217/2019 | 11-17 DORCAS STREET, SOUTH MELBOURNE

Section 87A Amendment Application

Prepared for
DORCAS DEVELOPMENT NOMINEES
22 December 2021

Table 2: Comparison of North Elevation

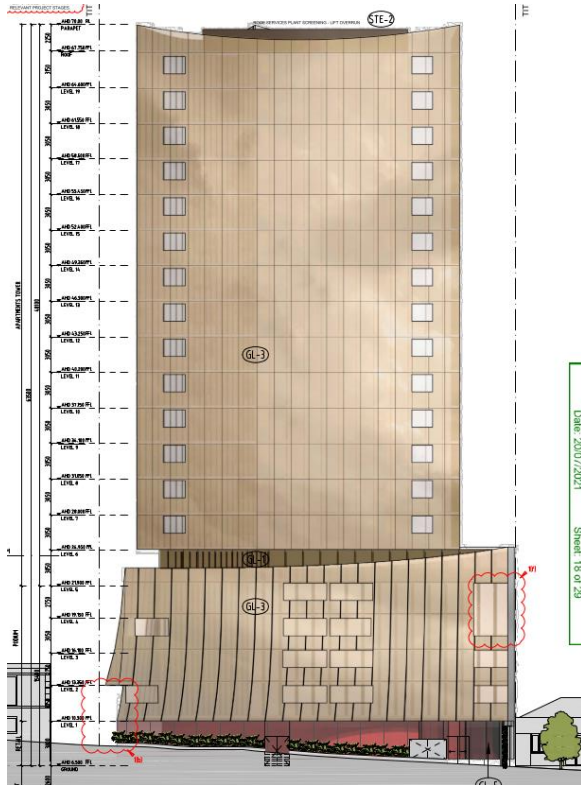
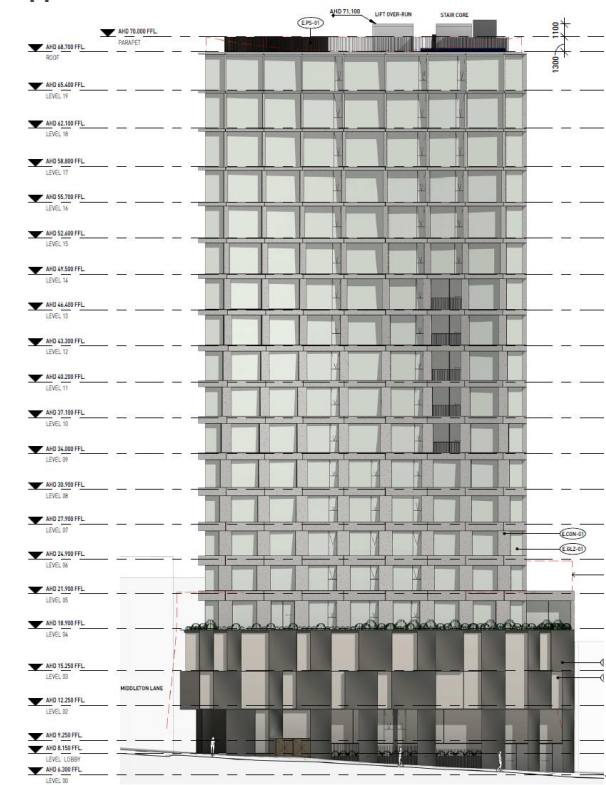
- Redesign of the entire façade treatment to create a robust form at the podium level with a concave gridded tower element above. Variations of concrete have been used in lieu of the formally proposed bronze glazing.

- Podium parapet height reduced from 18m to 12.6m.
- Removal of podium parking levels resulting in all parking being provided within five basement car parking levels.

Figure 8 Typical Tower Setbacks (Level 15)

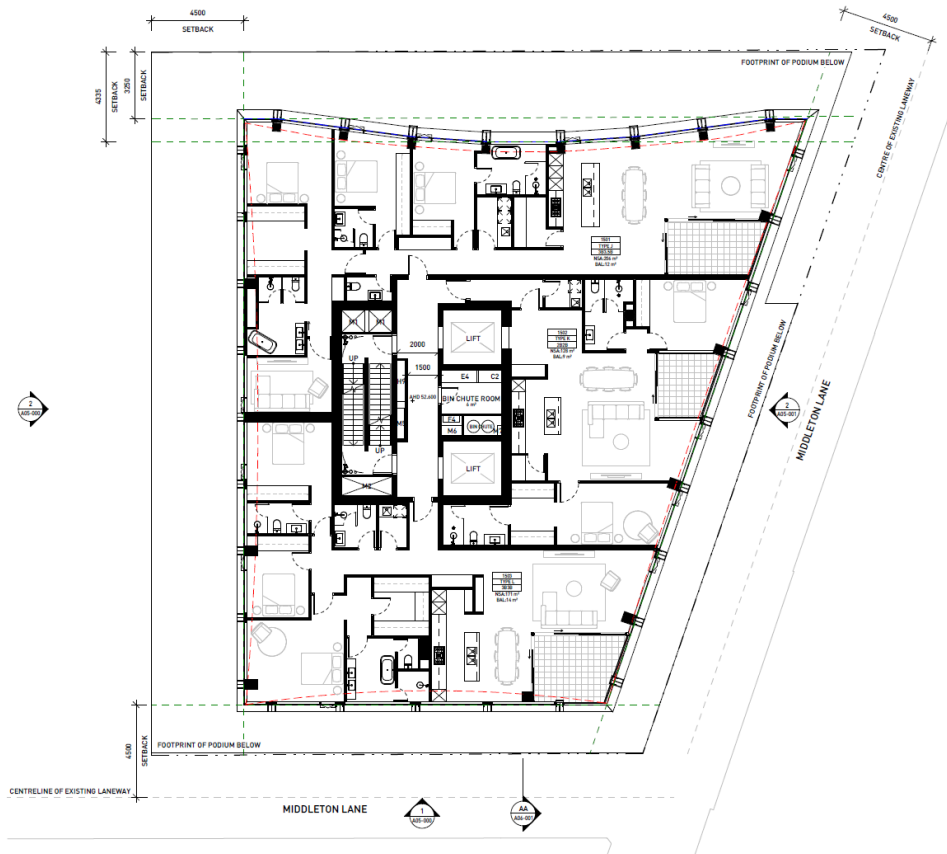
Figure 8 shows a typical tower floorplate with the red dotted line showing the formerly approved scheme. These setbacks are generally consistent with the approved scheme and compliant with DDO26.

We note that the grid form on the tower will protrude 350mm into the required setback. However, this is considered to be an architectural feature. Pursuant to sub-section 2.3 of DDO26, a permit may be granted to allow for architectural features on the exterior of the building within the area of a setback required by the schedule. As such, the proposed setbacks are considered to be appropriate.
